4F27E (FN4A-EL) INSTALLATION GUIDE

Ford 4-Speed Automatic Transmission

PRODUCT BULLETIN

UPDATED COOLER PORT SHOWN ABOVE IN RED

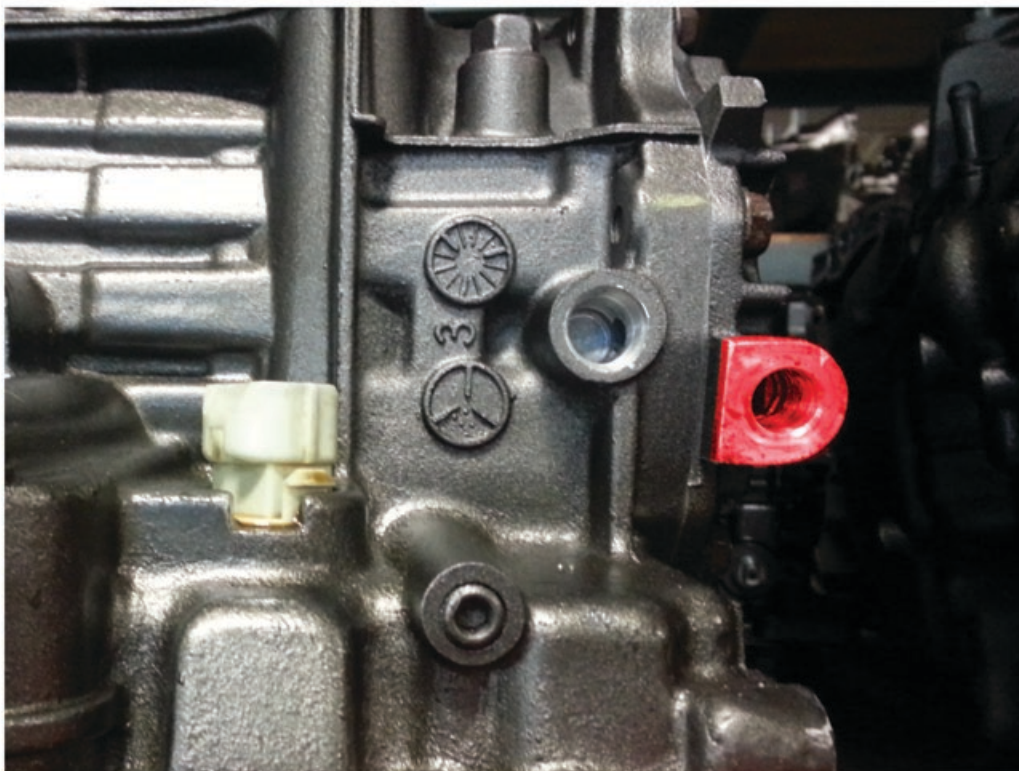
Due to premature rear cover failures in most Mazda applications, all of our remanufactured FN4A-EL (4F27E) transmissions are updated with the improved Ford-designed rear cover.

For Mazda applications only, the cooler return line **must be** relocated from the case to the end cover. During remanufacturing, the transmission is internally updated and the factory cooler line hole in the case is **permanently** sealed - all Ford applications will remain unmodified. Mazda units are updated to accept Mazda factory cooler line fittings (M14 x 1.50).

Note: If you install the return cooler fitting into the original case location there will be no lubrication provided to the rear of the transaxle and immediate failure will result and is **not** covered under your warranty.
